Vogle Units 1 & 2 Pre-Submittal Meeting 2: TSTF-51, TSTF-471, TSTF-490, and Alternative Source Term License Amendment Request

Tuesday May 10th, 2022

FIGURE 3.4.16-1
REACTOR COOLANT DOSE EQUIVALENT I-131 REACTOR COOLANT SPECIFIC ACTIVITY
LIMIT VERSUS PERCENT OF RATED THERMAL POWER WITH THE REACTOR COOLANT
SPECIFIC ACTIVITY > 1 μCi/gm DOSE EQUIVALENT I-131

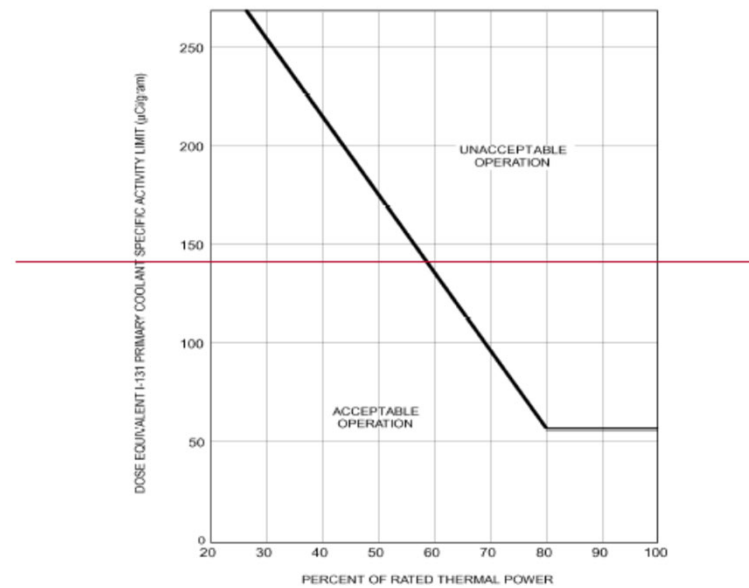
CONDITION	REQUIRED ACTION	COMPLETION TIME
A. DOSE EQUIVALENT I-131 not within limit 4.0 $\mu\text{Ci/gm}$.	A.1 Verify DOSE EQUIVALENT I-131 ≤ 60 $\mu\text{Ci/gm}$ within the acceptable region of Figure 3.4.16-1.	Once per 4 hours
	AND A.2 Restore DOSE EQUIVALENT I-131 to within limit.	48 hours
B. Gross specific activity of the reactor coolant <u>DOSE EQUIVALENT XE-133 not within limit.</u>	B.1 Be in MODE 3 with $T_{avg} < 500^{\circ}\text{F}$ <u>Restore DOSE EQUIVALENT XE-133 to within limit.</u>	6-48 hours

CONDITION	REQUIRED ACTION	COMPLETION TIME
C. Required Action and associated Completion Time of Condition A <u>or</u> B not met.	C.1 Be in MODE 3 with $T_{avg} < 500^{\circ}\text{F}$.	6 hours
<u>OR</u>	<u>AND</u>	
DOSE EQUIVALENT I-131 $> 60 \mu\text{Ci/gm}$ in the unacceptable region of Figure 3.4.16-1.	<u>C.2 Be in Mode 5</u>	<u>36 hours</u>
